From: [Westerdale, Barbara](#)
To: [Yokley, Bill](#)
Subject: PLEASE PDF--CLOUGH NR 512-3
Date: Friday, August 17, 2012 8:54:01 AM

From: Stanczyk, Jane
Sent: Monday, July 02, 2012 8:55 AM
To: Westerdale, Barbara; Freese, Steve
Cc: Davis, Gregory
Subject: FW: NR 512-3 update Clough NR 512-3 045-20524

Clough NR 512-3 045-20524

- Wellbore diagram outlining TOC, damage, MVRD, TOG, and TD

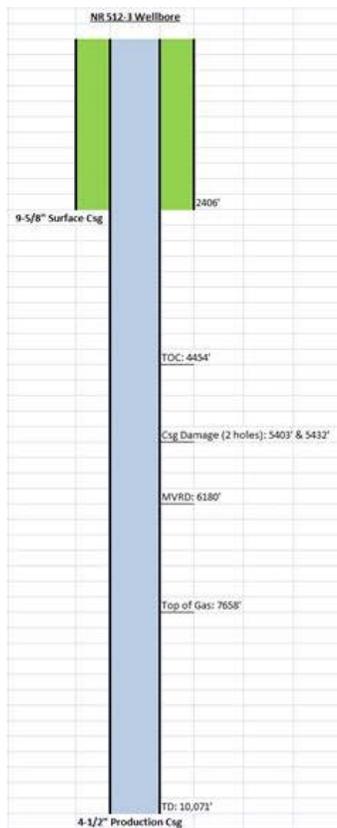
- MVRD: 6180'
- Top of Cement: 4454'
- The CBL can be found at the following site:

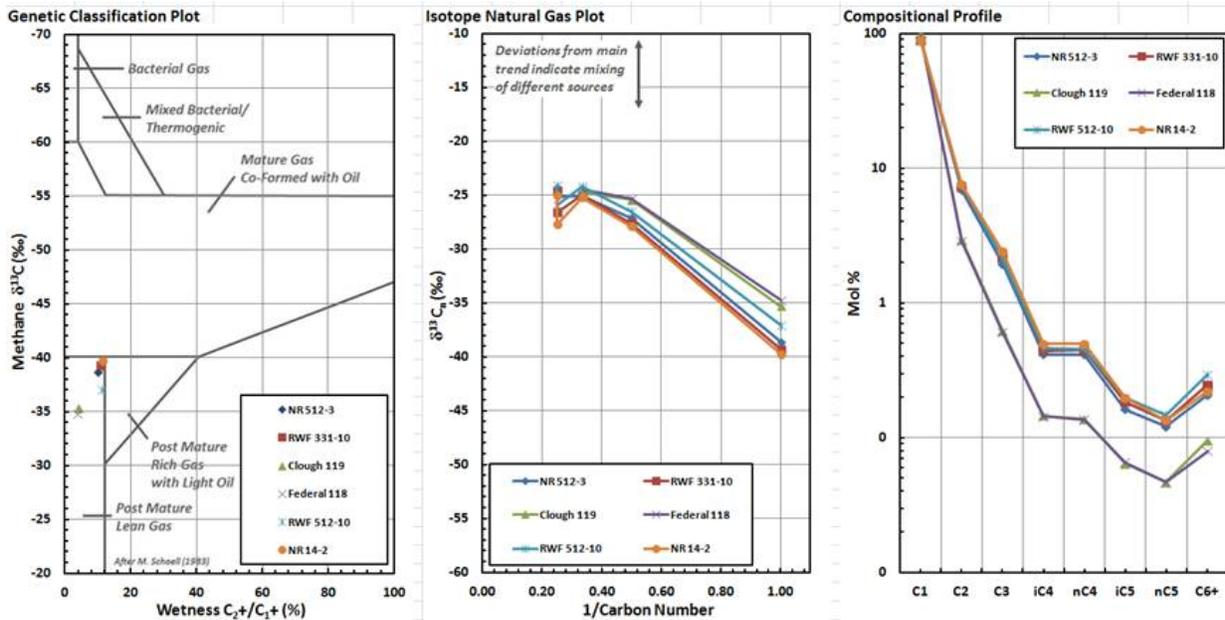
Secondly, WPX is permitted to produce gas from the Williams Fork formation. Gas samples were taken from the NR 512-3, as well as from the closest bottom-hole Wasatch (Clough 119 & Federal 118) and Williams Fork (RWF 331-10, NR 14-2, & RWF 512-10) wells, for comparison purposes. Samples were tested for composition, isotopes, and wetness. Conclusive results indicate that the gas being produced from the NR 512-3 is from the Upper Williams Fork. Please refer to the graphs below for gas analysis results:
